Bayside Planning Panel

Item No	6.1
Application Type	Development Application
Application Number	DA-2017/1235
Lodgement Date	7 December 2017
Property	18A Cowper Avenue, Pagewood
Owner	Christina Curry
Applicant	Rod Whitley
Proposal	Alterations and additions (including a first floor addition) to the existing dwelling and construction of an in-ground swimming pool
No. of Submissions	Two (2)
Cost of Development	\$375,000
Report by	Andrew Ison, Contract Planner

Planning Assessment Report

Application Number:	DA-2017/1235
Date of Receipt:	7 December 2017
Property:	18A Cowper Street, Pagewood
Lot & DP/SP No:	Lot A in DP 378977
Owner:	Christina Curry
Applicant:	Rod Whitley
Proposal:	Alterations and additions (including a first floor addition) to the existing dwelling and construction of an in-ground swimming pool
Recommendation:	Approve the development, subject to conditions
Value:	\$375,000
No. of submissions:	One (1) submission
Author:	Andrew Ison, Consultant Planner
Date of Report:	27 March 2018

Figure 2: Elevations

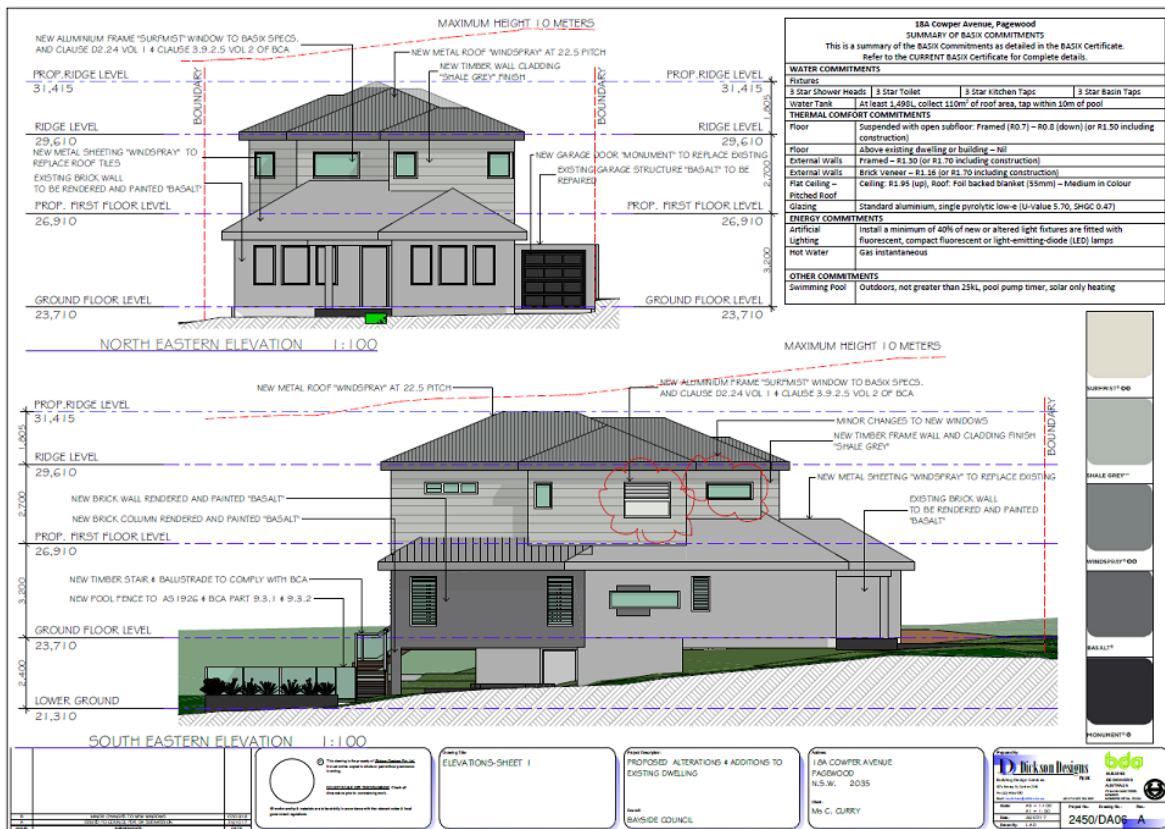
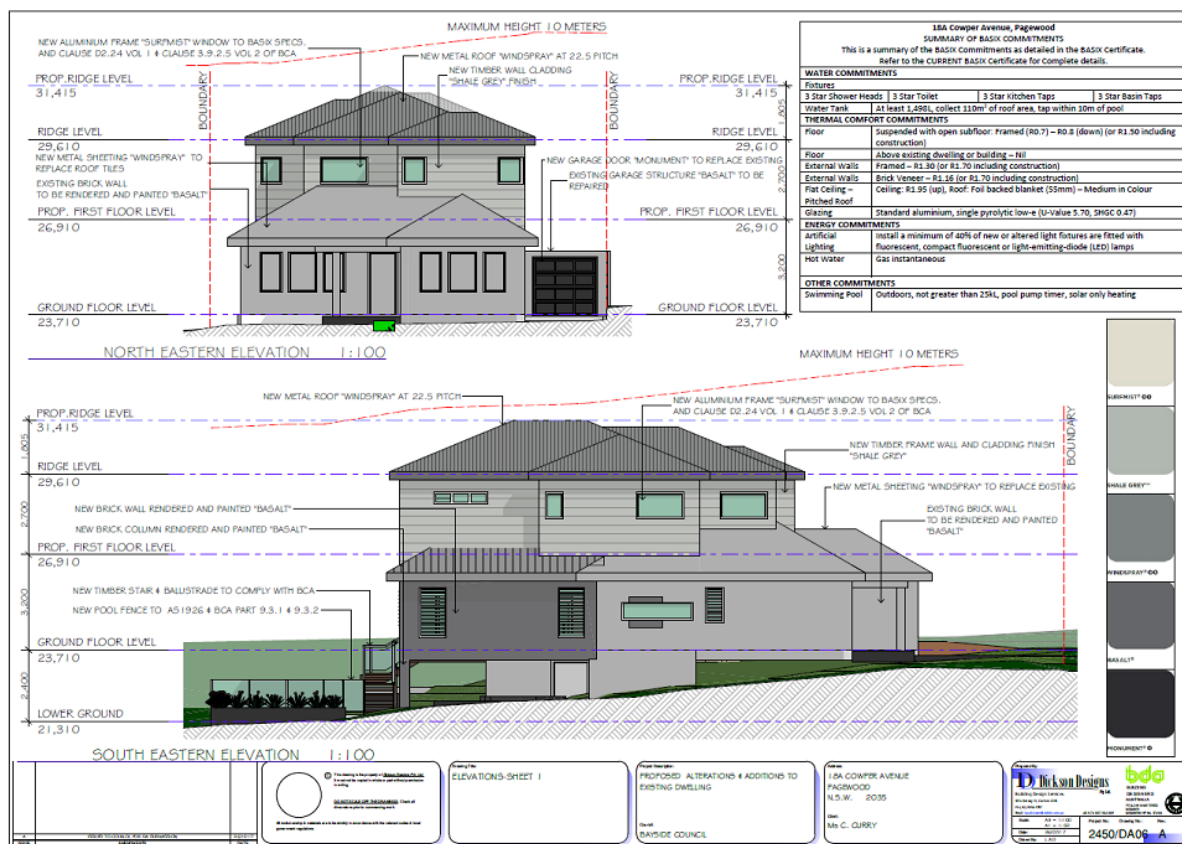
- ***Privacy concerns with respect to first floor bedroom windows***

Comment: Amended plans have been provided which has amended the windows on the south eastern elevation in which every bedroom window is either high-lighted or contains a privacy screen. However, a condition will be imposed to ensure that a similar treatment is provided for the master bedroom window on the south western elevation.
